Application No. 10/800,396
Paper Dated: August 22, 2005
In Response to Office Action Dated: April 22, 2005
Attorney Docket No. 0388-043714

AMENDMENTS TO THE DRAWINGS

FIG.5

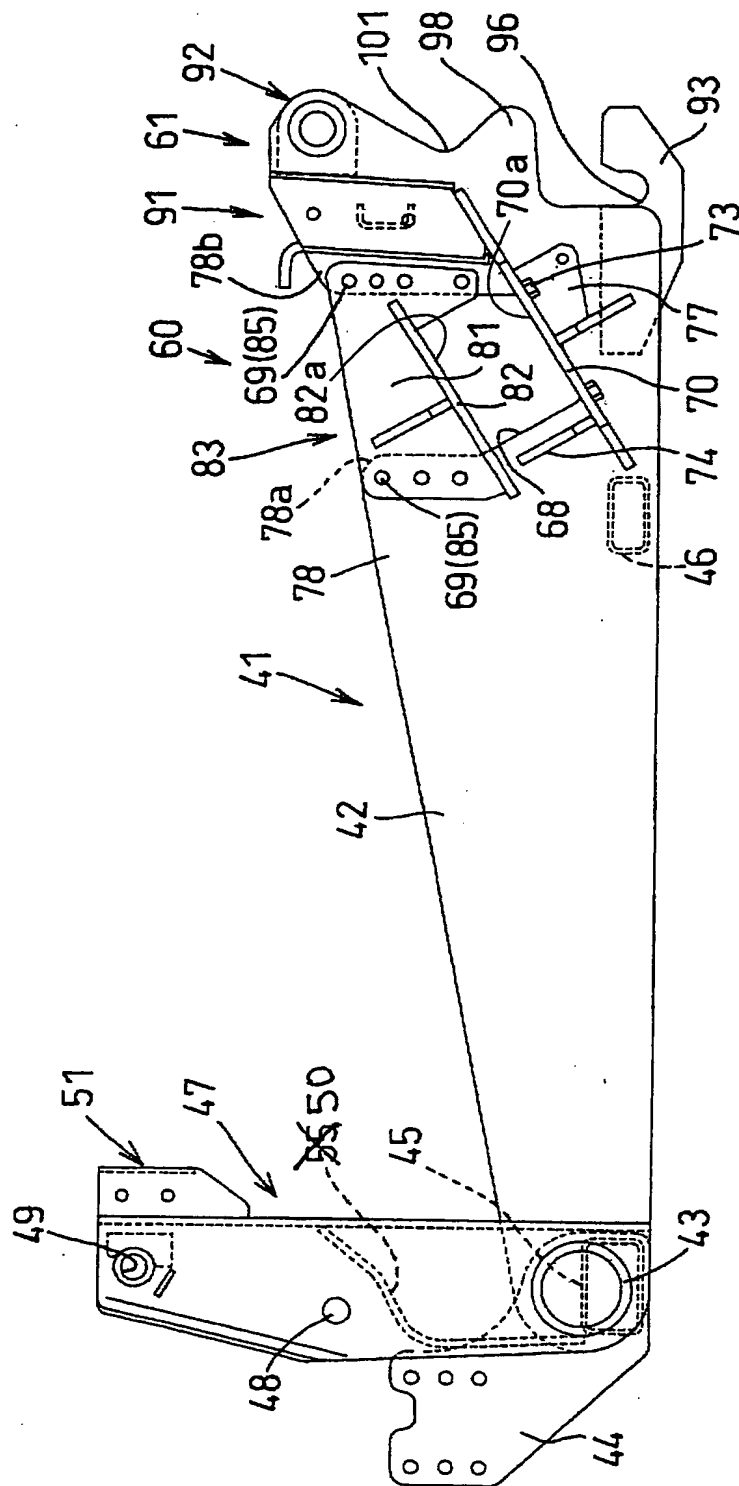
In the drawings, Fig. 5 has been amended to change previously labeled element 55 to element 50 in accordance with the remainder of the application such as, for example, Fig. 8. Fig. 14 in the drawings is further clarified by labeling the cutout opening sides 79 with lead lines as described in the written description at page 14, lines 28-30, for example.

In Fig. 5, previously labeled element 55 has been changed to element 50. In Fig. 14, the cutout opening sides (element 79) have been labeled.
